CERTIFICATE OF APPROPRIATENESS

Property: 836 Fugate, Lot 1, Block 205, Norhill Subdivision. The property includes a historic one-story wood frame single-family resident and a detached garage situated on a 6,136 square foot (59' x 104') corner lot.

Proposal: Alteration – Windows and Door

EAST SIDE ELEVATION

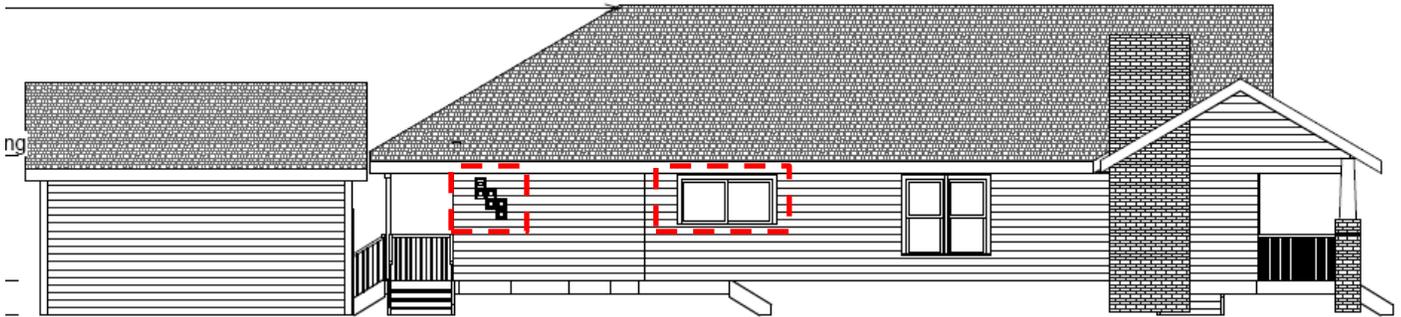
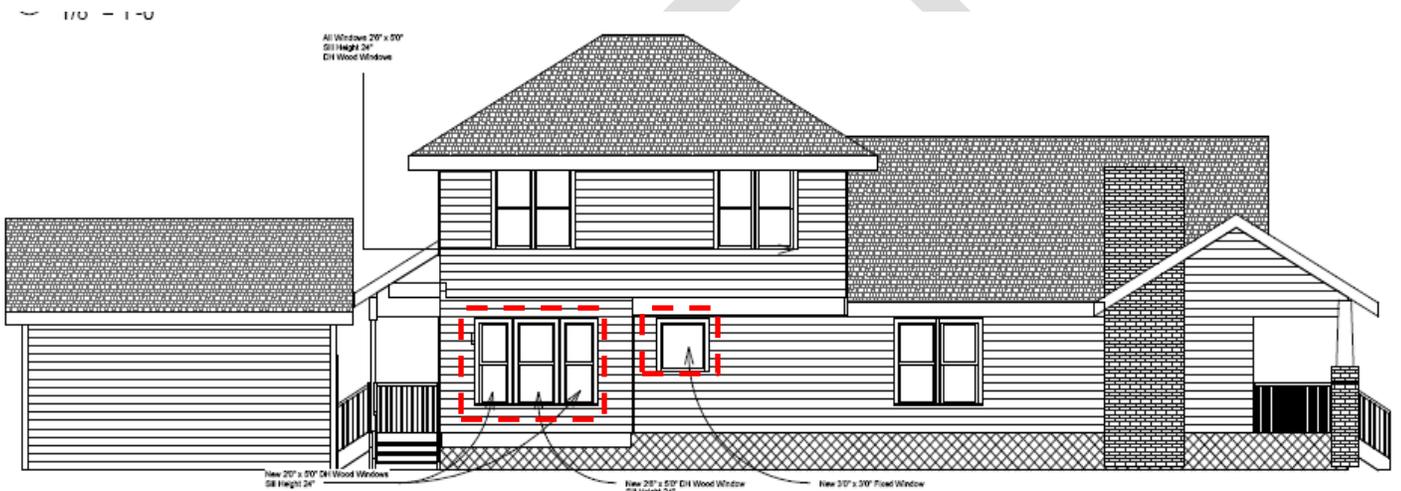
<i>The original house features all wood 1-over-1 windows and the proposed fixed window on the east elevation does not retain and preserve the historical character of the property</i> |

<i>The original house features all wood 1-over-1 windows and the proposed fixed window on the east elevation seeks a later appearance.</i> |

<i>The original house features all wood 1-over-1 windows and the proposed fixed window on the east elevation does not maintain or replicate the style of window that is found throughout the original house.</i> |

Recommendation: **Approval with conditions: Approval to replace the glass block windows with 1-over-1 wood windows. Approval of a 1-over-1 wood window (to match other windows on the existing structure) in place of the proposed single light fixed window.**

SOUTH (REAR) ELEVATION

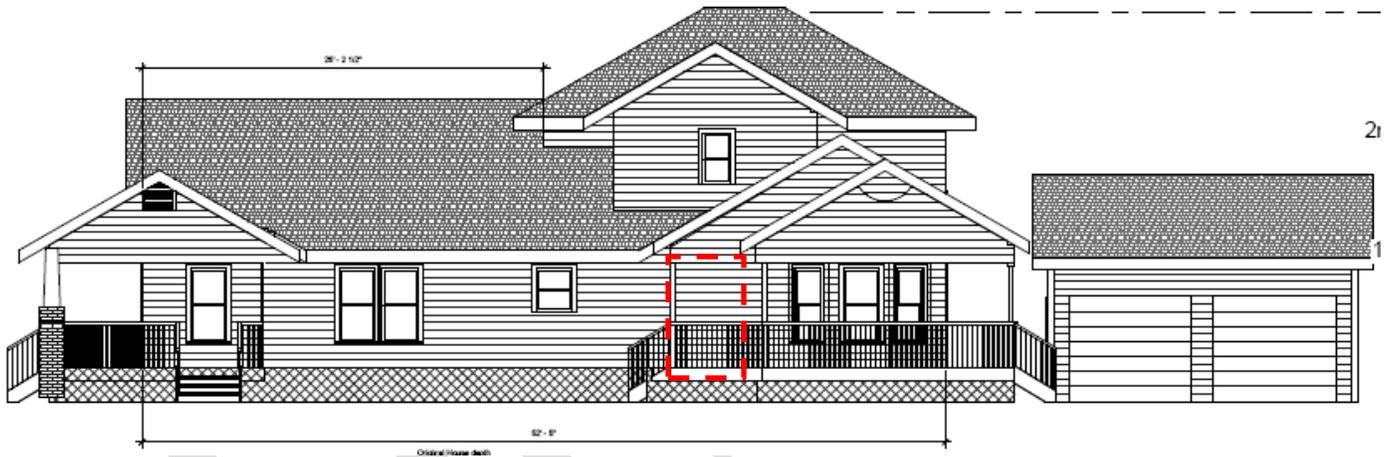
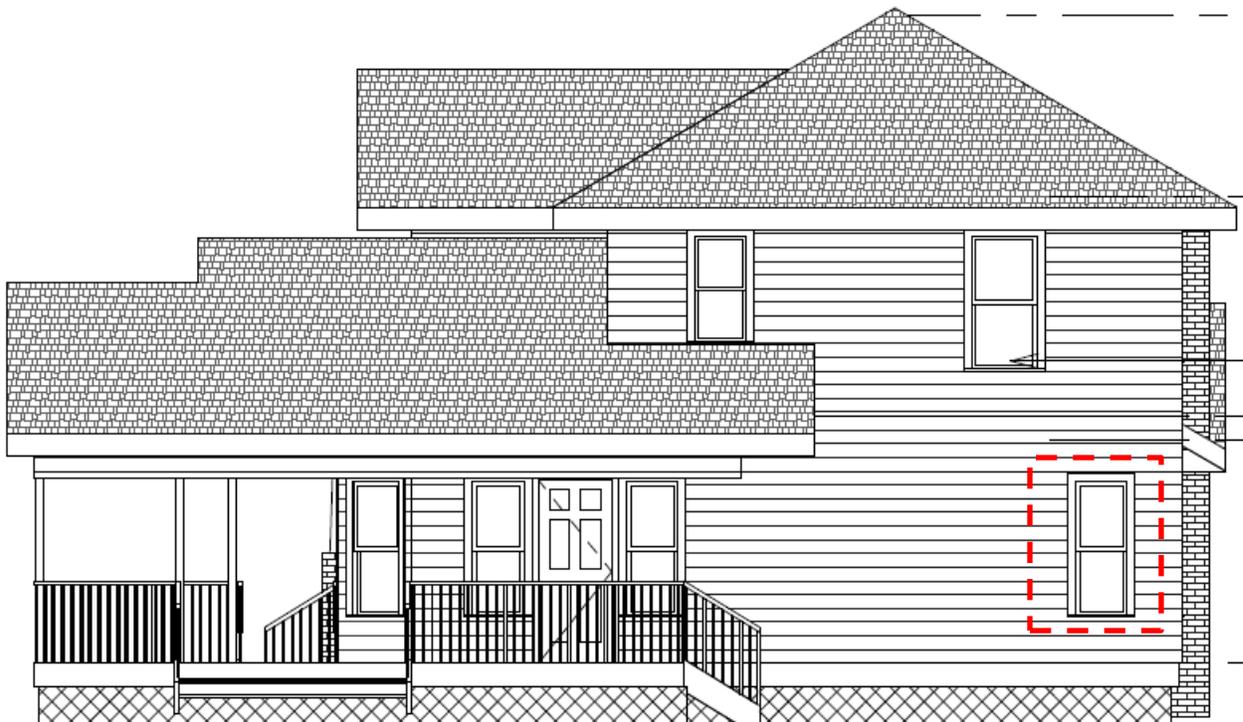
Proposed: The non-original glass block will be removed and replaced with one, 1-over-1 wood window.
